TECHNICAL NOTE

JBA Project Code	2020s0838
Contract	Mumbles Coastal Protection Scheme
Client	Amey Consulting
Day, Date and Time	16 March 2021
Author	Katie Corbett
Reviewer / Sign-off	Anne-Marie Moon
Subject	Mumbles Coastal Processes Review

This technical note is a review of the 2017 coastal processes report, aiming to identify new data and guidance to inform the design of the Mumbles Coastal Protection Scheme. Specifically, this report covers:

Figure 3-2: Beach profiles at section 202.

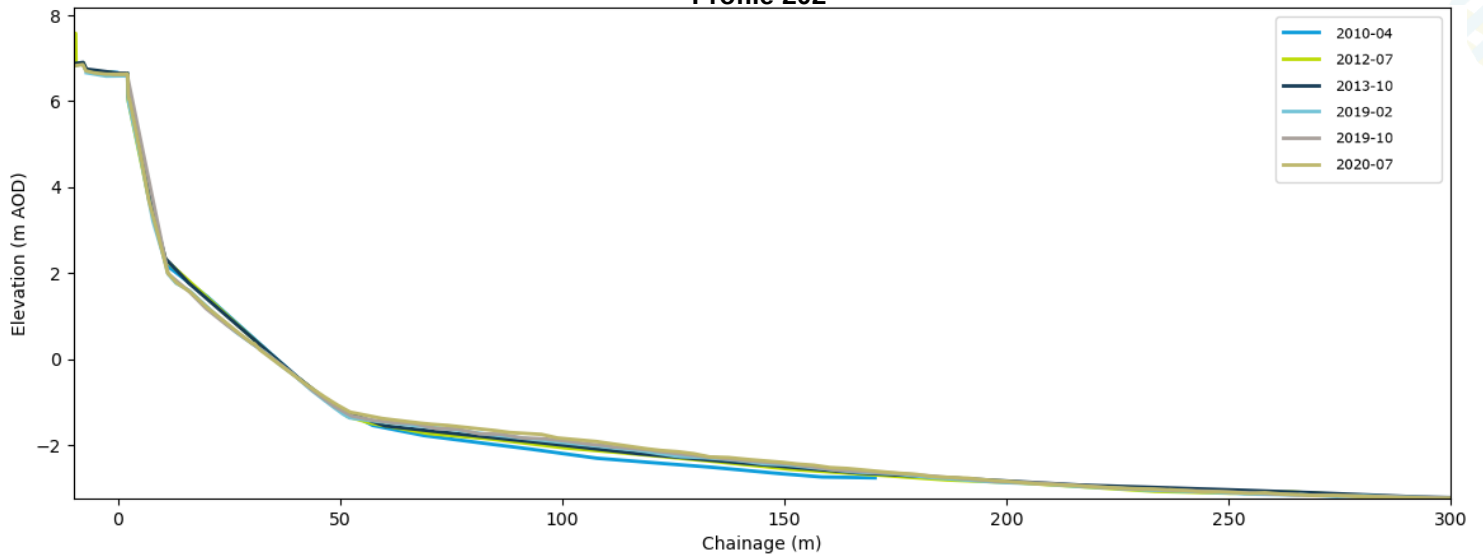
Further topographic data for Mumbles is now available from the 2019 and 2020 surveys. This data has been obtained from the WCMC and plotted alongside the original data used in the 2017 review (Figure 3-2 and Figure 3-3). The more recent survey data indicates some lowering of the foreshore at the toe of the sea wall compared to earlier surveys.

Figure 3-4: Beach profiles at section 202 – toe of defence

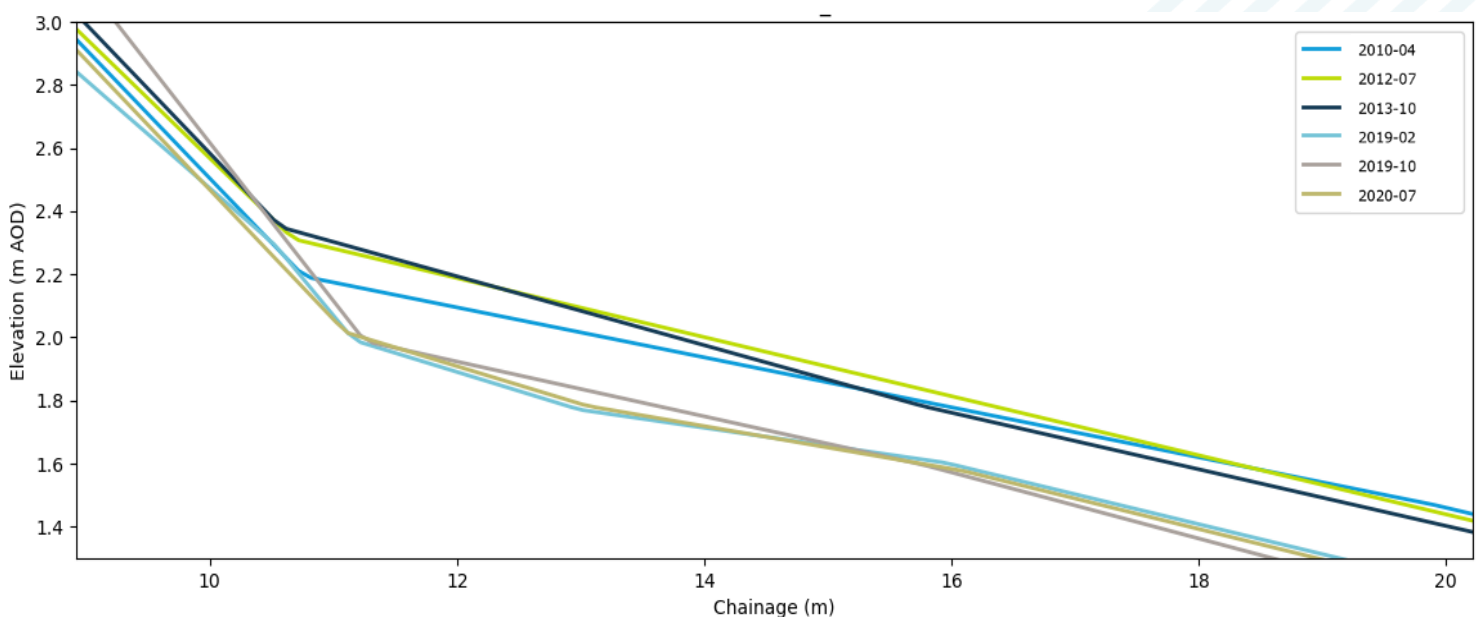
Figure 3-4 and Figure 3-5 provide detailed plots of the toe levels at the two profile locations. Figure 3-4 shows the beach profile at the toe of the defence for the 202 profile (southern profile). Between 2010 and 2013, there was a minor build-up of material at the defence toe of approximately 0.2m, as reported in the 2017 report. This build-up of material was not sustained; the toe level was recorded at 2m AOD in the February 2019 survey, approximately 0.4m lower than the 2013 toe level. The toe level remained at approximately 2m AOD in the most recent survey in July 2020. Although there is a lack of data between 2013 and 2019, the data indicates that the toe and upper-foreshore levels may have not recovered to previous levels. In total, 0.4m of variation in toe and upper-foreshore levels has been recorded at this profile from 2010 to 2020. The potential for a longer-term trend of toe and upper-foreshore lowering should not be ruled out.

It is recommended that the potential for lowering of the upper-foreshore, particularly around the northern defence profile, should be taken into account in the designs. It should be noted that the length of the available beach profile data set is limited and there is insufficient data to identify clear long-term trends in a dynamic beach environment. It is therefore recommended that coastal monitoring continue once the proposed scheme is implemented.

Figure 3-5: Beach profiles at section 203 – toe of defence

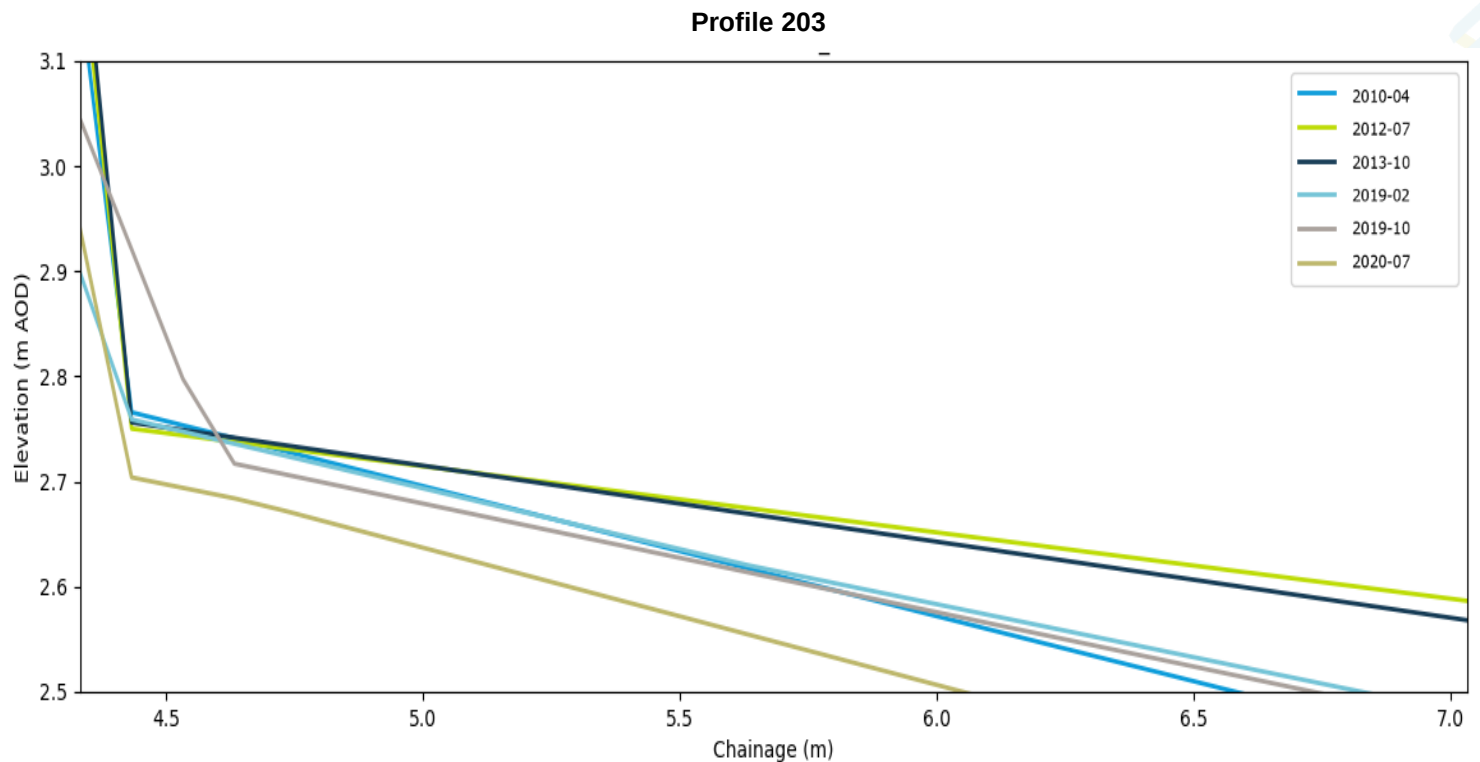
Figure 3-5 shows the beach profile at the toe of the defence for the 203 profile (northern profile). Between 2010 and 2013, there was a very minor drawdown of material at the defence toe, as reported in the 2017 report. Continued drawdown at the toe is seen in the October 2019 and July 2020 surveys; the toe level was recorded at 2.7m AOD in July 2020, a total drawdown of approximately 0.5m since 2010. From the data available, there is no evidence of accretion of material along this profile over the 10-year period since the first profile record. Therefore, the topographic surveys suggest the potential for a longer-term trend of toe and upper-foreshore lowering at this profile location.
